TECHNICAL NOTE

Job Name: Lands at Burfield Valley and Reef Way
Job No: 49366-2001
Note No: TN01
Date: 30/07/2020
Prepared By: Anthony Thorpe
Subject: **Drainage Statement & Planning comment responses for the 6 Home Development**

- 1.1. Persimmons Homes South East have commissioned Stantec UK Limited to provide drainage advice associated with a change in land use on an individual plot adjacent Reef Way, Hailsham, East Sussex.
- 1.2. This note is intended to support planning application WD/2018/1271/F and respond to planning comments and requirements provided on 16.01.2020 & 17.01.2020.
- 1.3. This note should be read in conjunction with the following documents:
 - 49366-2001-TN03
- 1.4. This note is deemed to supersede PBA document 43124 TN002 issued on 22/05/2018.

Figure 5.1 - Extract from PBA Drawing 24336/003/010 Rev D

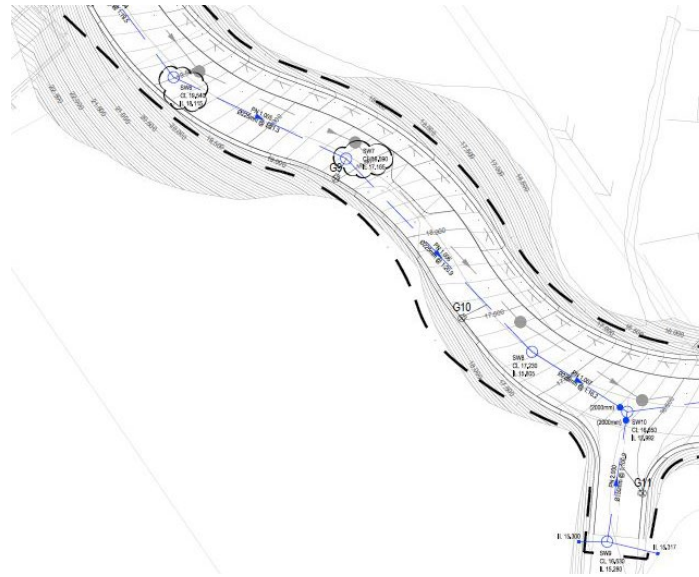
5.1.2. The extract below, from PBA drawing 24336/003/010 Rev D, shows the main surface water network running down reef way as a 225mm dia. pipe and the pipe within the turning head as a 150mm dia. pipe
